**HISTORIC PRESERVATION COMMISSION
REGULAR MEETING (ELECTRONIC)
APRIL 23, 2020
ZOOM MEETING PLATFORM &
ASSEMBLY HALL
395 MAGNOLIA ROAD
PINEHURST, NORTH CAROLINA
4:00 PM**

PLANNING AND INSPECTIONS DEPARTMENT STAFF REPORT

To: Historic Preservation Commission
From: Peter Hughes, Senior Planner
CC: Darryn Burich, Planning and Inspections Director
Kelly Brown, Administrative Specialist
Date: May 20, 2020
Subject: Major COA Request for 335 Linden Road (COA-2020-00052)

To: Historic Preservation Commission
From: Peter Hughes, Senior Planner
CC: Darryn Burich, Planning and Inspections Director
Kelly Brown, Administrative Specialist
Date: May 20, 2020
Subject: Major COA Request for 600 Linden Road (COA-2020-00051)

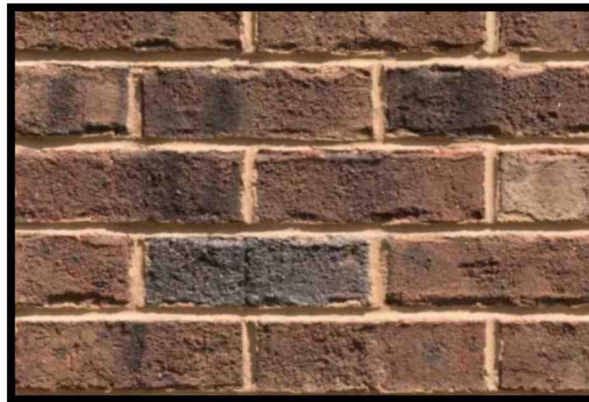
The proposed siding material is fiber cement for both the horizontal lap and vertical accent siding. Fiber cement siding is hardie board, which has been a material the commission has approved in the past. The use of hardie board is not explicitly compliant with the Guidelines, however would be congruous with other structures in the Historic District. The proposed paint color is Grizzle Gray (SW7068), which is congruous with the Historic District and consistent with cottage style homes.

The proposed trim material is MiraTec Trim Boards that will be used for the porch beam, garage and window casings. MiraTec is a composite wood that combines the authentic woodgrain look with the longevity of an engineered product. According to the Historic District Guidelines, the use of engineered wood product on existing structures is permitted, but must not cover other wooden

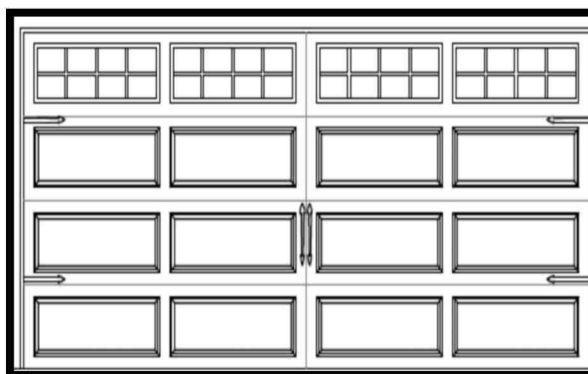
The proposed foundation material is a brick veneer from the triangle brick company. The proposed brick foundation is congruous with other structures within the Historic District and is an appropriate material according to the Historic District Guidelines.

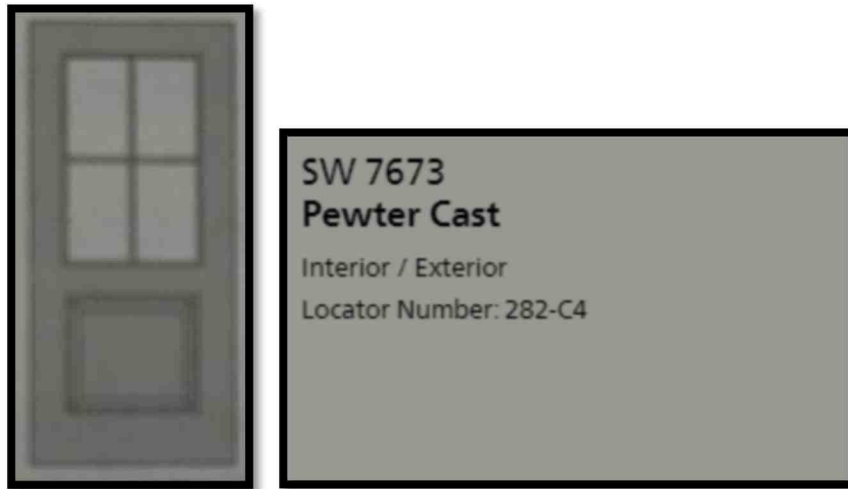
The proposed garage door is a ranch door panel, white in color featuring faux hardware and glass window inserts. The proposed style of the garage door and inclusion of glass windows is congruous with other structures in the Historic District.

The proposed front door is a Masonite door, featuring 2 over 2 glass panel and the proposed paint color is Pewter Cast (SW7673). It is unclear from the application what the base material is for the proposed door. Masonite products can be composed from wood, fiberglass, and steel none of which would be out of character with other doors in the Historic District.

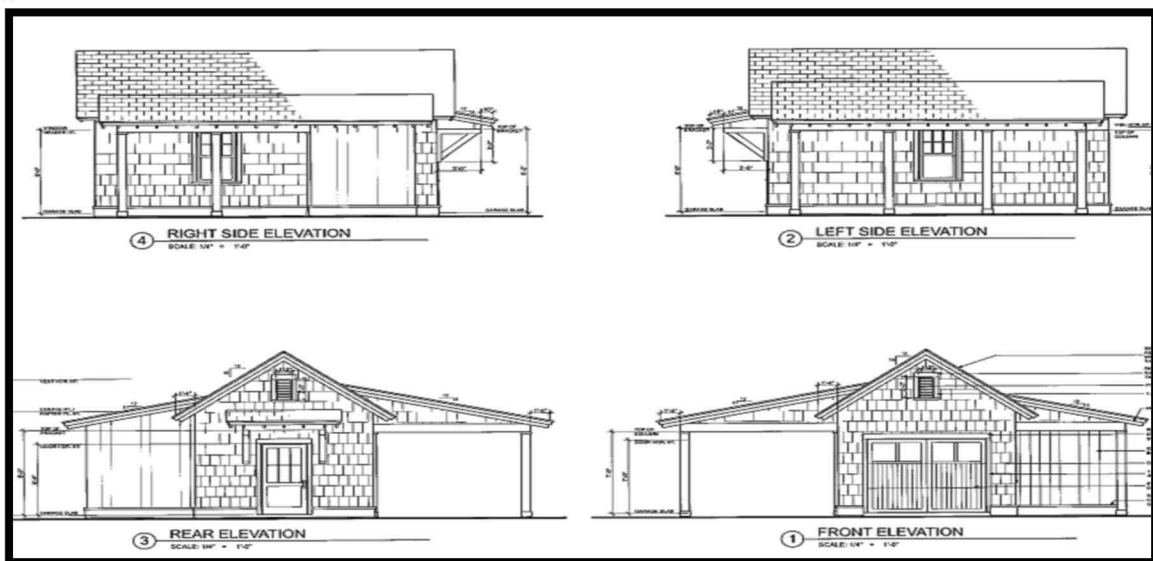
The proposed new construction also includes the construction of a detached garage. The proposed garage will be constructed to match the style of the home and would be congruous with other detached garages in the historic district.

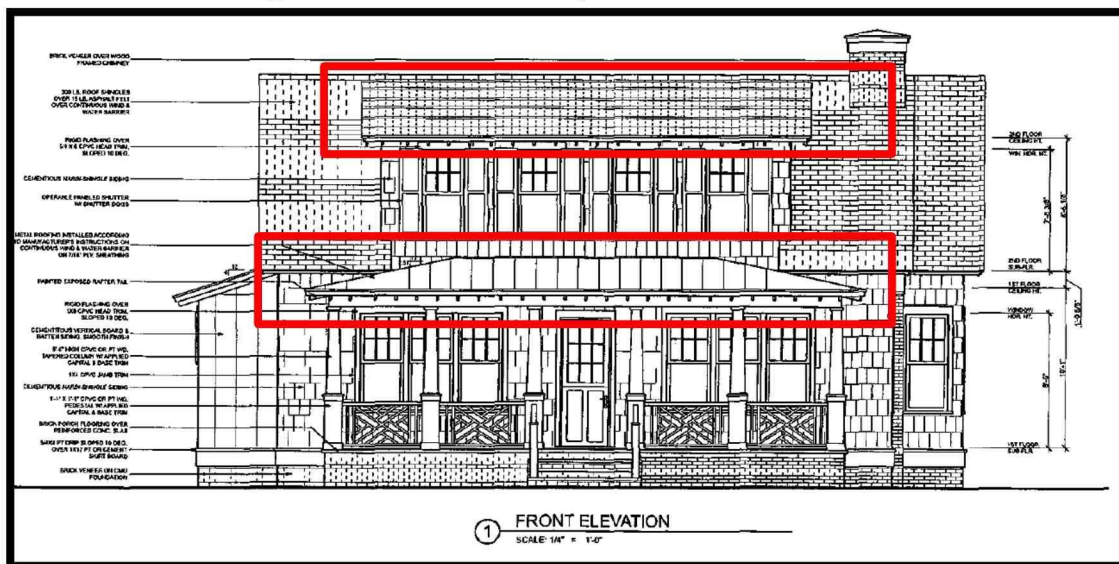
The proposed material for the garage door is steel, which is a permitted material. At this time it is unclear whether the proposed garage door would be congruous because the application package did not include an elevation of the garage.

The application and elevation has indicated two different roofing materials. One of proposed roofing material will be a composite architectural shingle, which is complaint with the guidelines and congruous with other homes in the historic District. The other proposed roofing material is metal, which will be used for the porch and is congruous with the historic district. The proposed colors are black shingles and white metal roof.

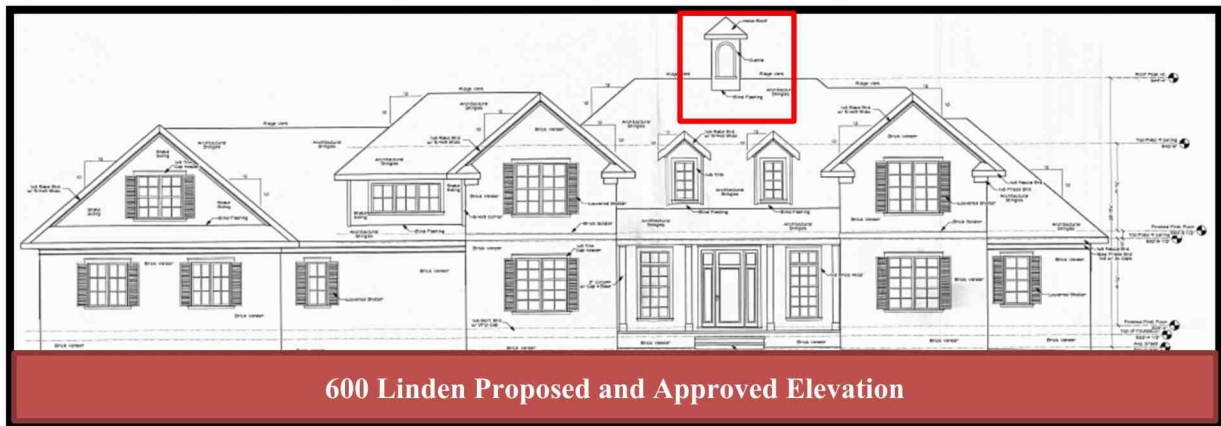
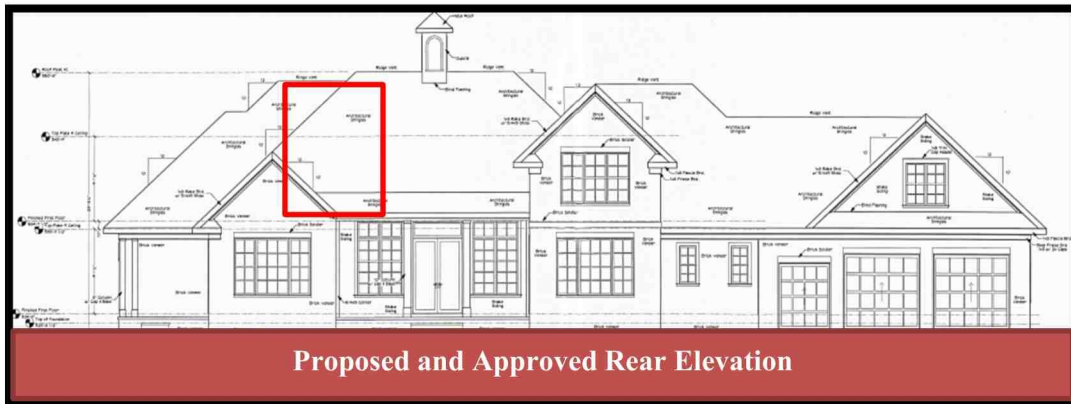
This request is before the Commission because modifications were made to a previously approved COA that would be considered Major Work. During construction the following modification were made: (1) a change in roofing material from approved shingles to metal, (2) addition of a chimney and relocation of a cupola modifying the proposed roofline and architectural detail, (3) the architectural design of the front door was changed and proposed transom windows on the rear elevation were not constructed.

During construction the proposed cupola was relocated from center of the structure to the left side of the structure, in between the center of the structure and the garage. It is a change from what was proposed however, it is still complaint with the guidelines and compatible with the architecture.

During construction a chimney was added to the rear of the structure. The addition of a chimney adds a distinct architectural detail and additional character to the home. By adding the chimney the applicant did, however modify the approved roofline. The chimney is not visible from the street and chimneys are common throughout the Historic District. While modifications to the roofline are not encouraged, this modification is compatible with the architecture of the structure and does not negatively impact the historic character.

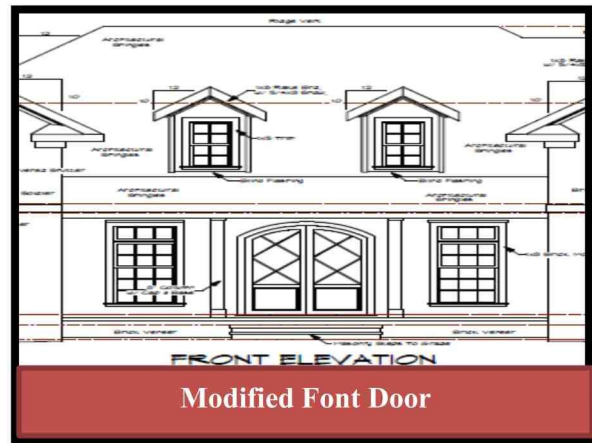
During construction the applicant altered the design of the front door and did not construct the proposed transom windows on the rear elevation.

The commission originally approved a traditional style, wood front door surrounded by transom windows (shown below). The constructed front door is a radius top country French door. The change is not significant, however it was a change that was not approved. The French style door makes the entrance more prominent and adds some diversity to the very linear and square front façade of the structure. This modification is compliant with the historic district guidelines and compatible with the colonial esque architecture.

On the rear of the home the approved plans showed the inclusion of a transom window above the French doors on the rear patio. The applicant ending up not construction the transom window and removing them from the design. This elimination of the transom window is a relatively minor modification. Transom windows are a minor architectural detail and the change occurred on the rear of the home causing no effect to the look of the front façade. This is new construction and the colonial architectural design is not lessen without the transom windows.

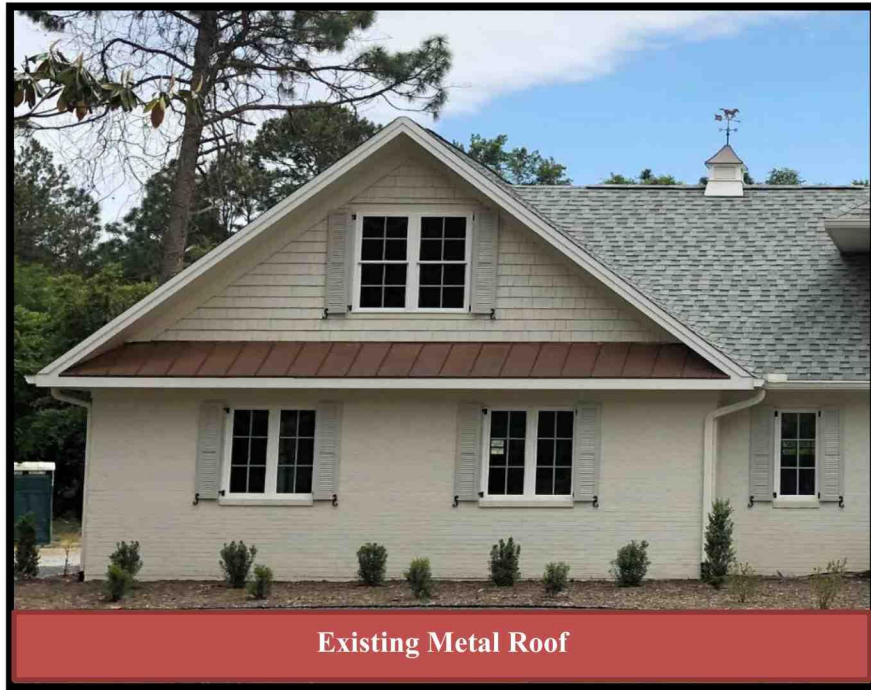
1. New chimneys or chimney repairs and alterations should be compatible with the architectural character of the structure and must be congruous with chimneys in the Pinehurst Historic District.

The chimney, which was added during the course of construction is compatible with the existing architecture of the building. The chimney is constructed using the same brick to match the rest of the home and the chimney has the copper flashing surrounding the base, matching the flashing of the rest of the home.

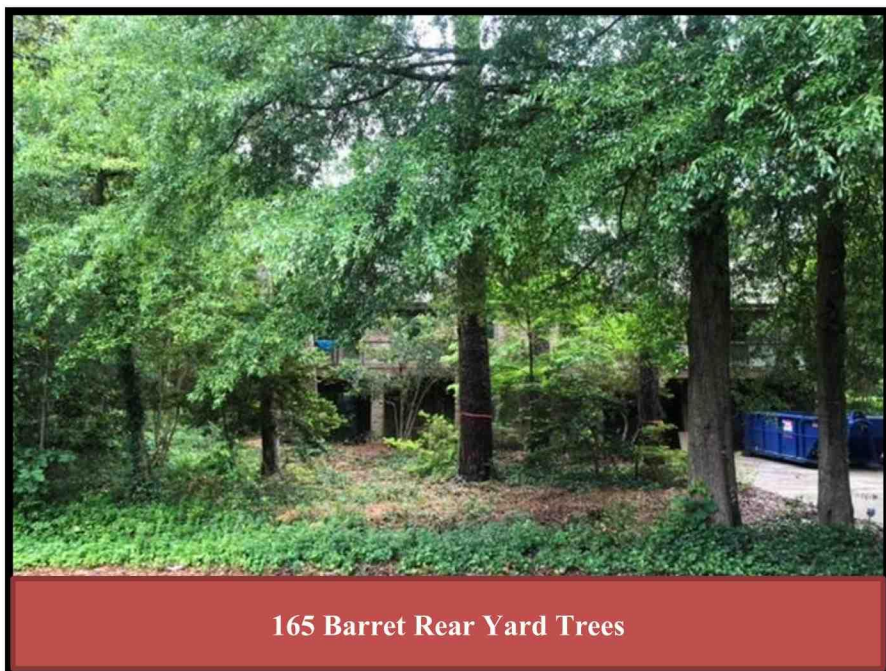
Please [click here](#) and review the Working with Real Estate Agents Brochure.

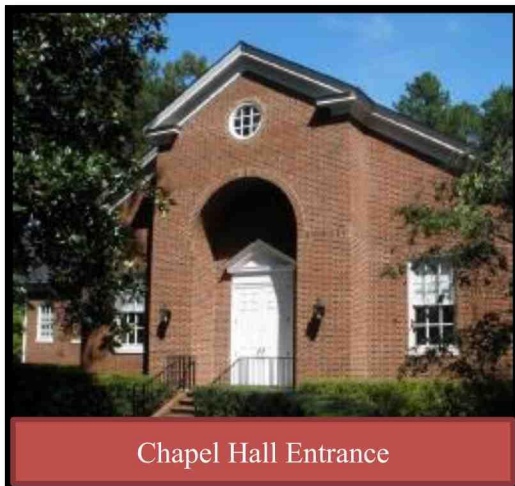
Shutters have not been proposed based on the submitted application and elevations.

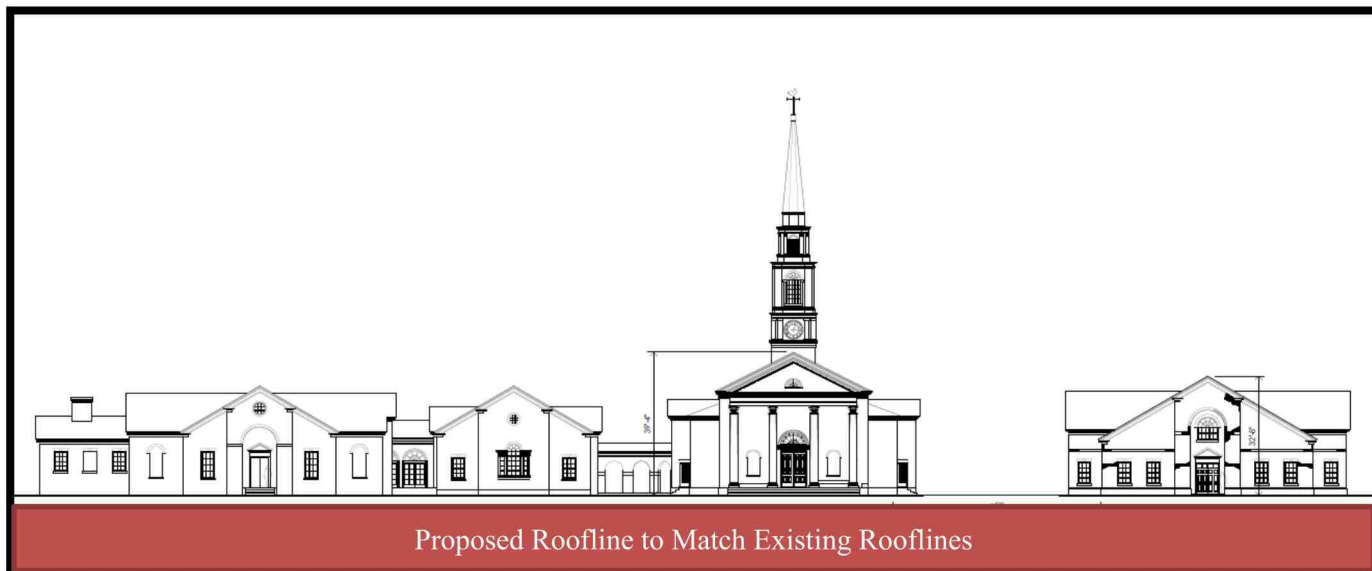
1. Section IV.E.1 - All proposed site features and accessory buildings, including garages, and other buildings, as well as other structures such as gazebos, patios, arbors, and pergolas, must be compatible with features of the principal structure and must be congruous with other accessory structures in the Pinehurst Historic District.
